Preliminary & Final Drainage Report
for
Rex Road
through
Falcon Regional Park

MERIDIAN RANCH
A GOLF & RECREATIONAL COMMUNITY

EL PASO COUNTY, COLORADO

February 2023

CHANNEL 1 Plan: Plan 01 1/23/2023

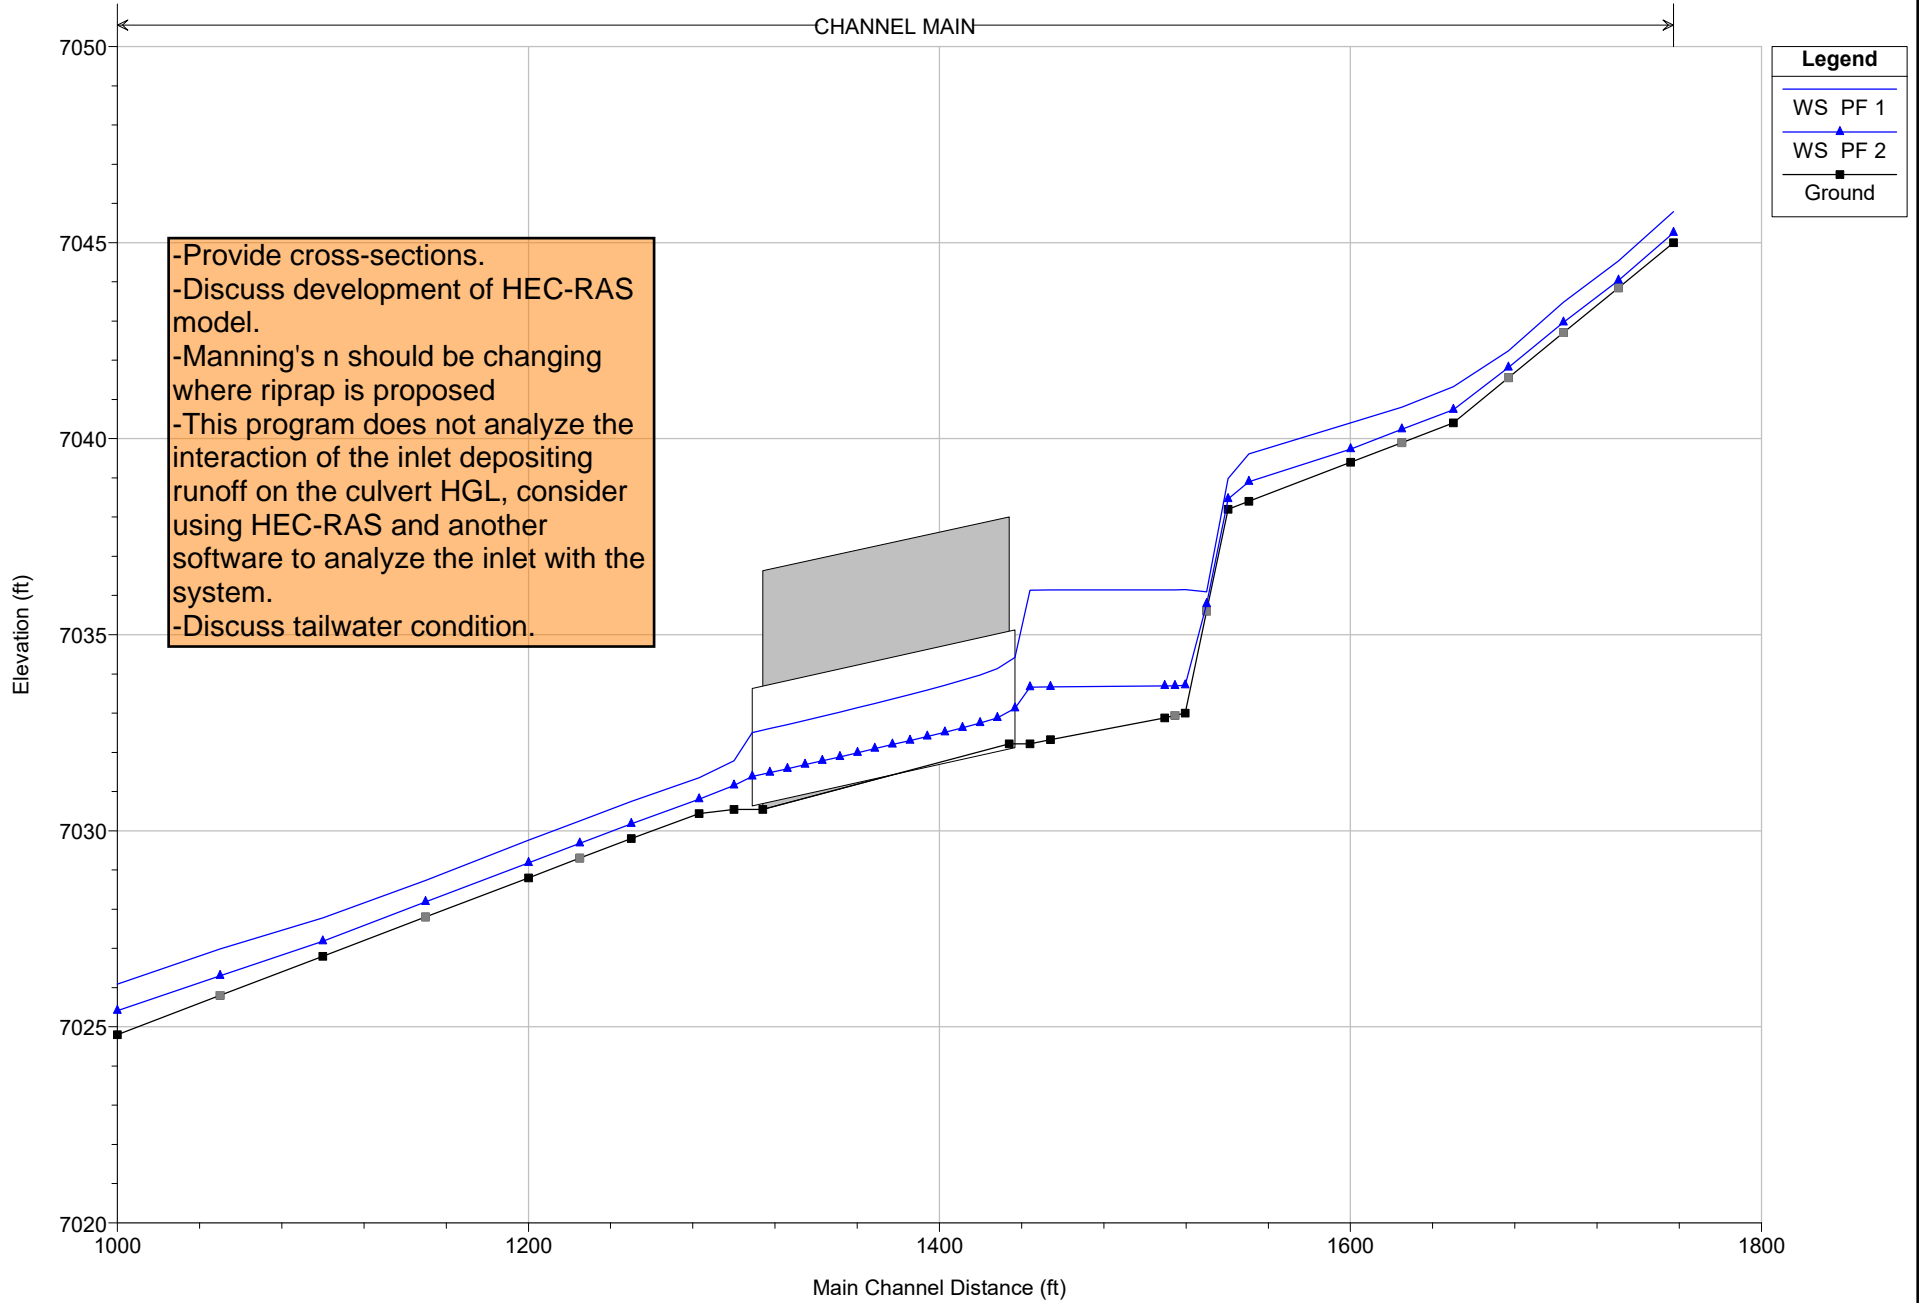
What watershed contributes to the culvert? I do not see a Q that matches the 50 cfs or 10 cfs max flows shown in the culverts. Label which watersheds contribute and where the change in flow occurs. State which storm frequencies are being analyzed.

Provide hydraulic analysis for all storm drain system - Storm #2 is not analyzed per the plans.

Soil Map

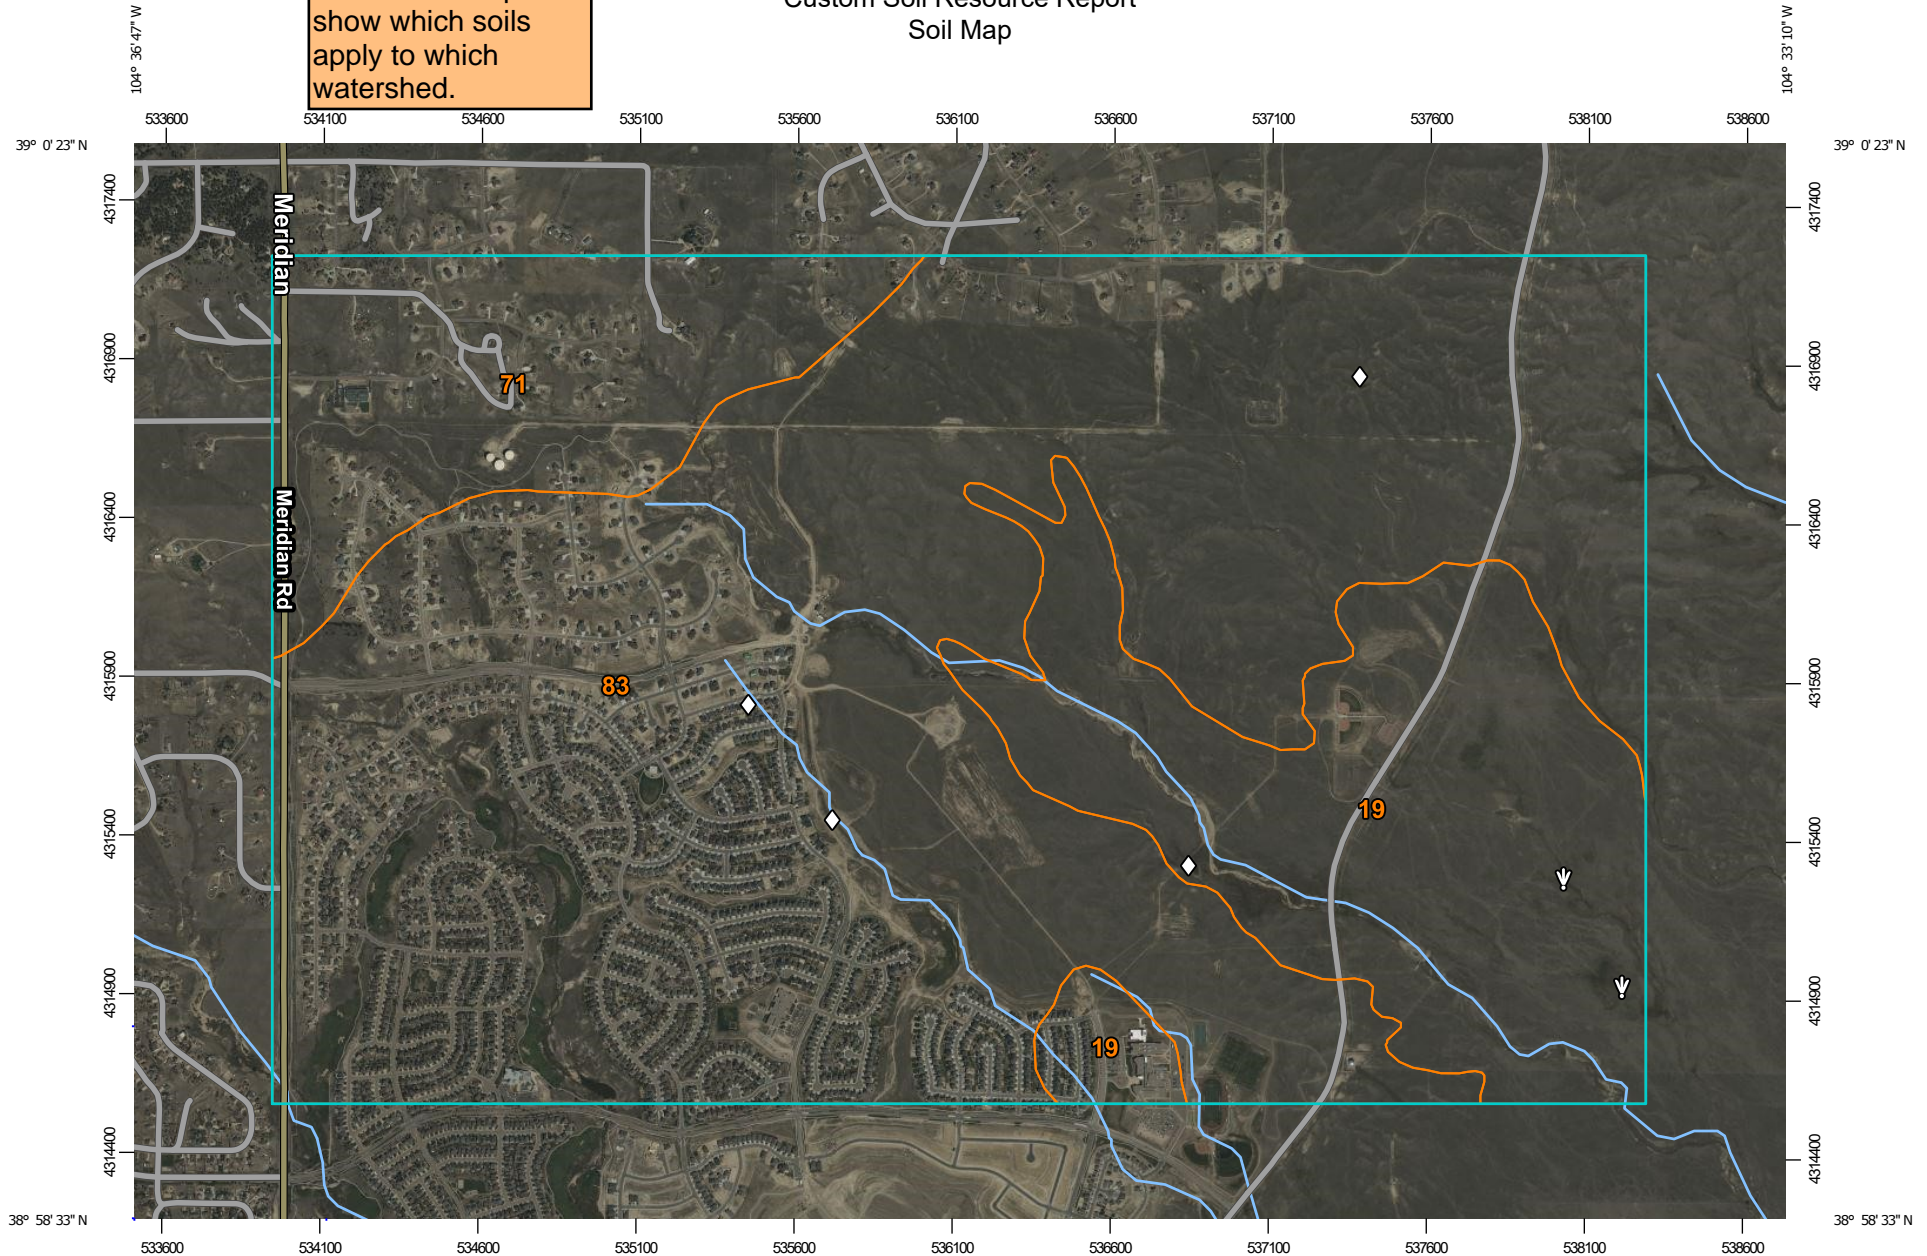
Show watershed area in soil map to show which soils apply to which watershed.

FIGURE 5

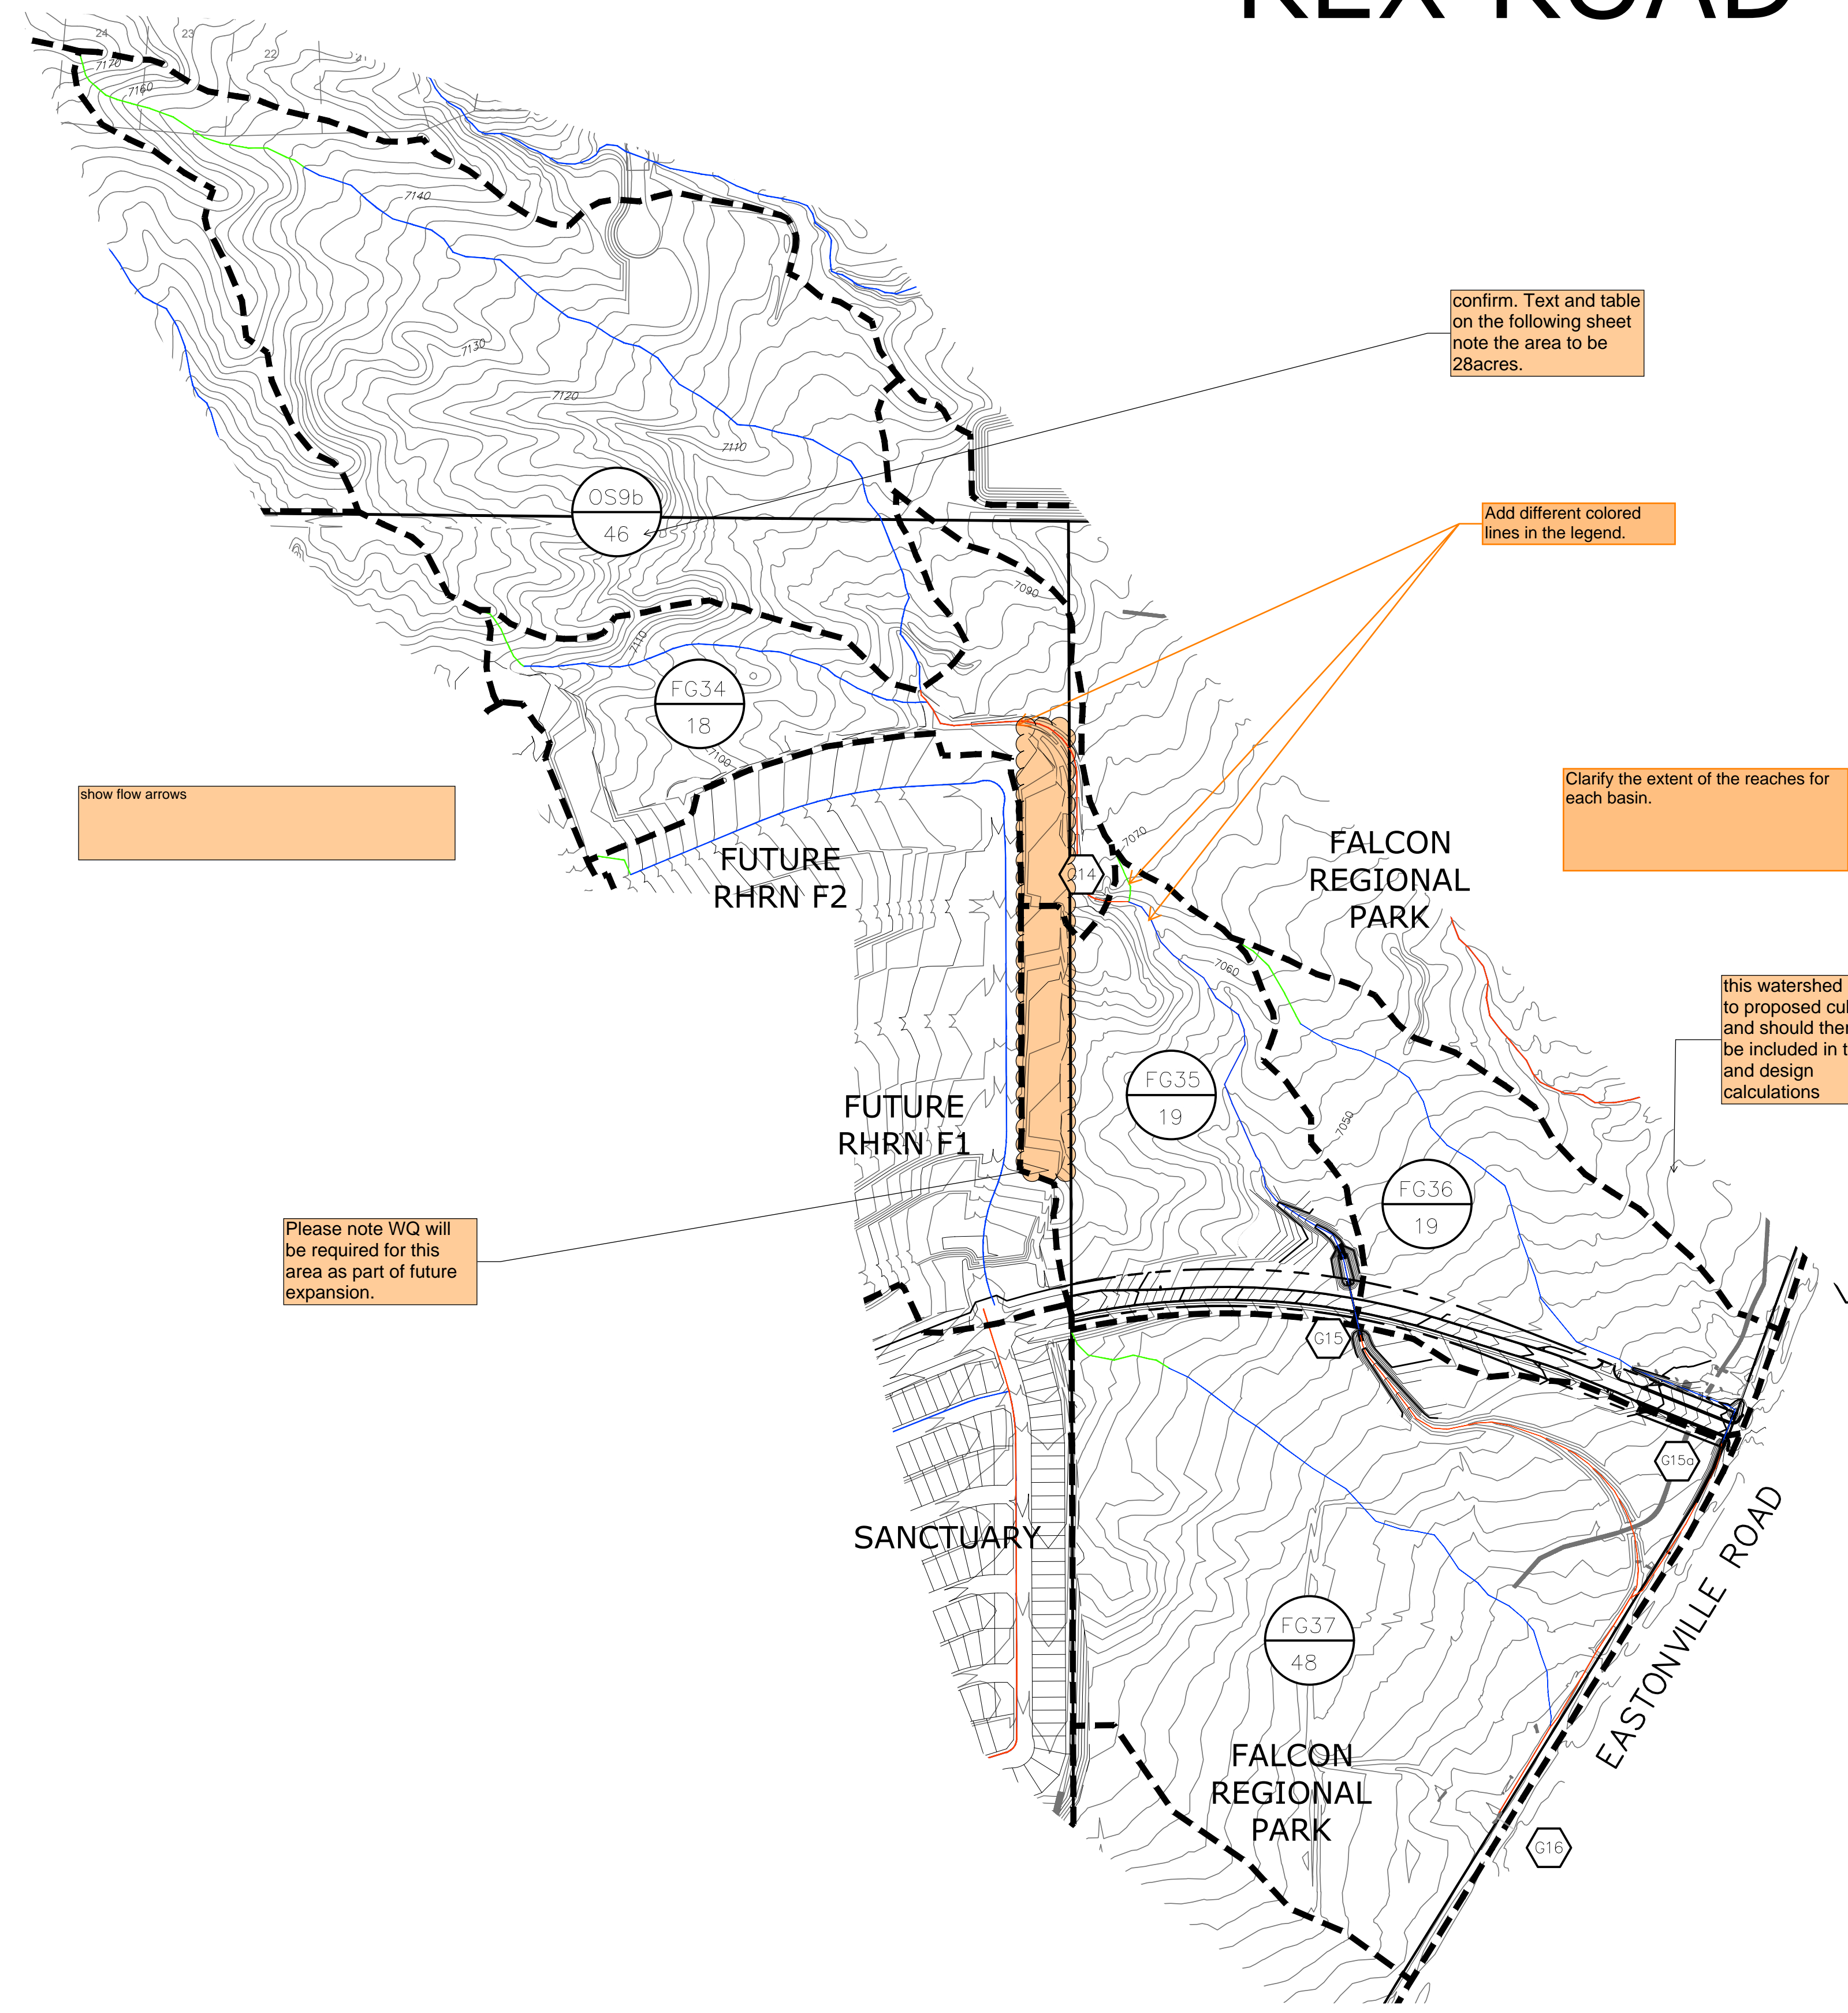
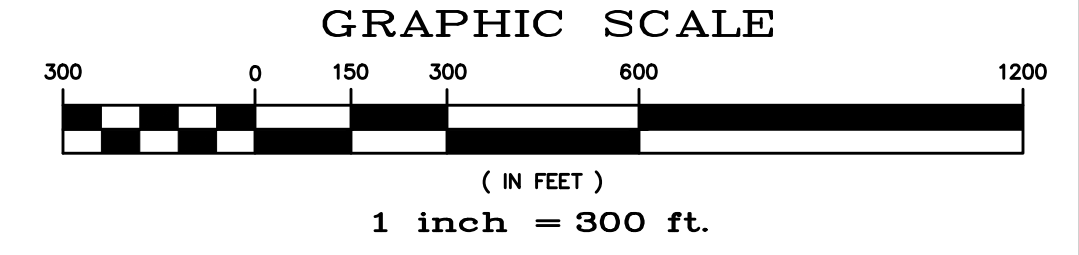
confirm. Text and table on the following sheet note the area to be 28acres.

Add different colored lines in the legend.

Clarify the extent of the reaches for each basin.

show flow arrows

Please clarify if this is the future or interim conditions that is being shown on this map.
